RESPONSE TO REVIEW COMMENTS

**PL-002614-2023 | 19 West Street
Portland, Maine 04101
Project #23-020**

Town of Kennebunkport Planning Board
6 Elm Street
Kennebunkport, ME 04046

WATERSHED MAPS

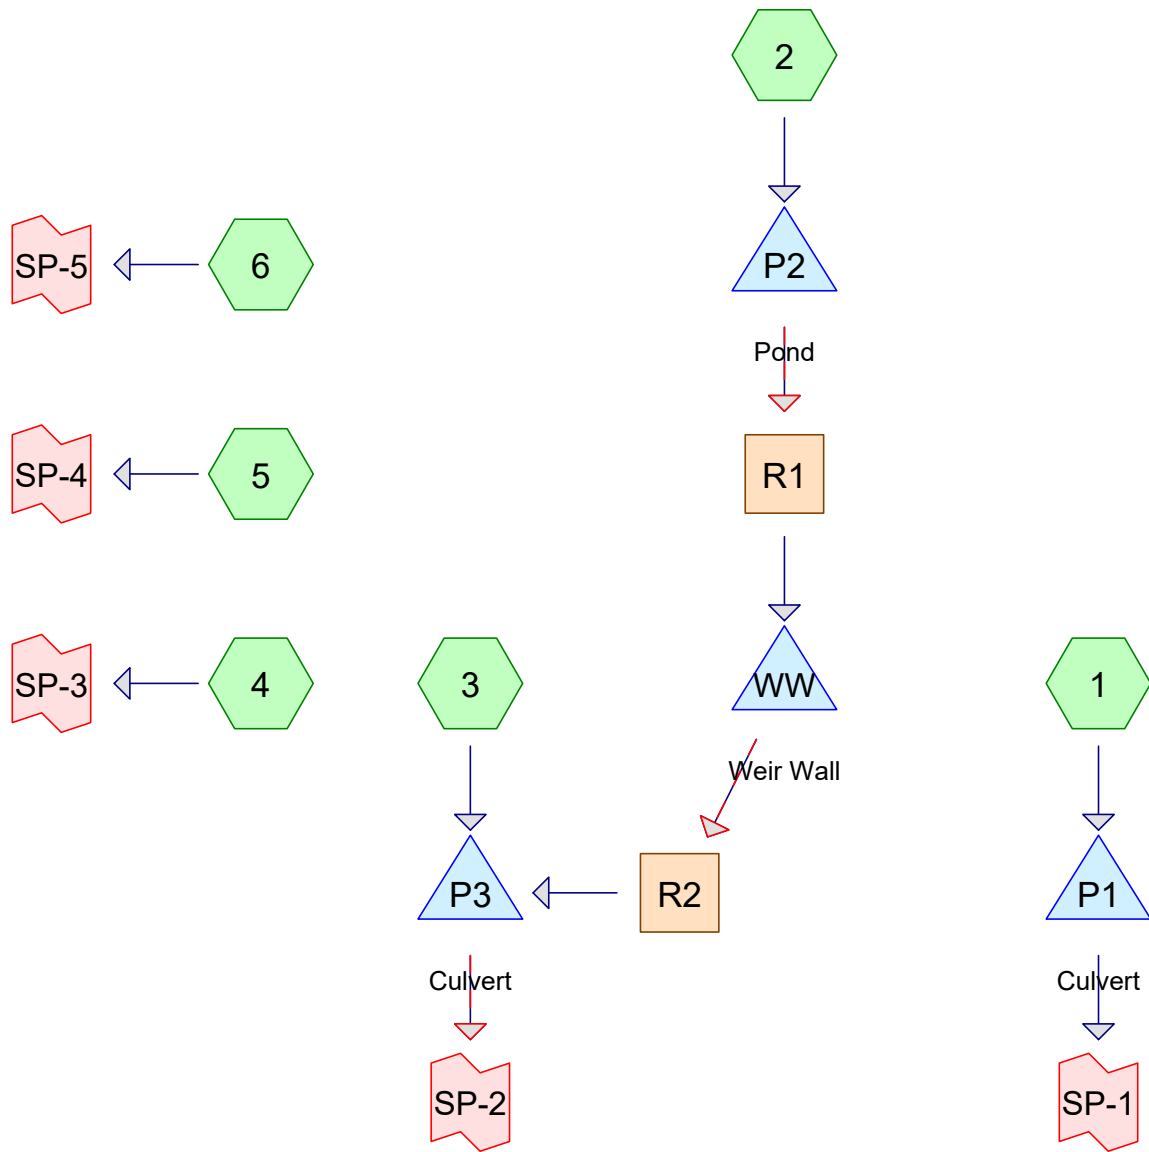
- a. Appendix 1: Re-evaluate TC path for Subcatchment 1. Acorn believes there may be a longer path with a longer stretch of sheet flow from the northeasterly corner.
- b. Appendix 2: Re-evaluate the drainage divide between Subcatchments 10 and 11. The current drainage divide is between the 78 and 79 contours, whereas the divide appears to be closer to the middle of Lot 2.
- c. Appendix 3: The TC path for Subcatchment 2 is longer in the post-development condition than existing.
- d. Appendix 4: The inlet invert of Reach 22 has a higher elevation than the outlet of the receiving culvert (C22).
- e. Appendix 4: The size of the pipe outlet from C22 should be 18-inches as depicted on the plans.
- f. Appendix 4: The size of the pipe outlets from C21 and C22 should be 18-inches as depicted on the plans.

- a) The TC path starting in the northeasterly corner was evaluated. While sheet flow is slightly longer, the overall time of concentration is shorter than the original path.
- b) There is a high point near the 79' contour to allow drainage from Lot 2 to flow to the existing pond in subcatchment 20. However, watershed lines had not been updated to reflect the most recent changes. Spot grades have been added to show the high points and the outer boundary of subcatchment 11 has been updated to reflect those changes.
- c) TC paths have been adjusted so that Subcatchment 2 in the pre-development condition is longer than in the post development condition.
- d) The inlet invert has been adjusted for Reach 22 to match the receiving culvert outlet.

- e) **The size of the pipe outlet from C22 has been changed to 18 inch as depicted on the plan.**
- f) **The size of the pipe outlets from C21 and C22 have been changed to 18 inches as depicted on the plan.**
